Appendix B

Mark 2 LHCS Non-compliance Elements and Proposed Mitigation

Interior of Mark 2 Coach toilet

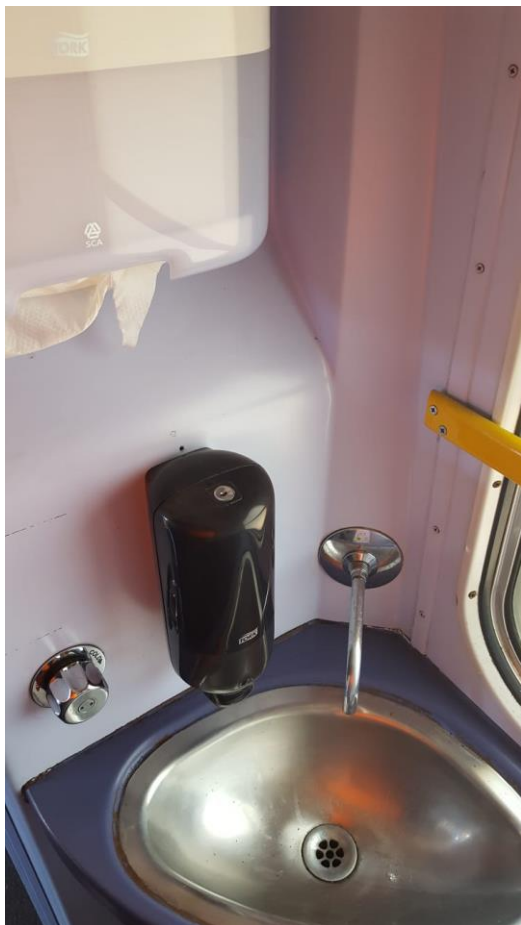
- Door access width;
- soap dispenser operating forces;
- tactile labelling.

The standard (non-accessible) toilet doorway is only 428mm wide, while the PRM-TSI requires a minimum of 500mm width. This is a fundamental aspect of the construction of the train and cannot be easily improved without changing the vestibule and saloon layout to relocate the door.

The soap dispenser operating forces are above the 20 Newton limit, typically between 42 and 53 Newtons. A soap dispenser with a compliant operating force has been sourced for the refurbished HSTs and ScotRail will retrofit this onto the Mark 2 vehicles.

The labelling currently fitted is not tactile and ScotRail will replace it with tactile labelling.
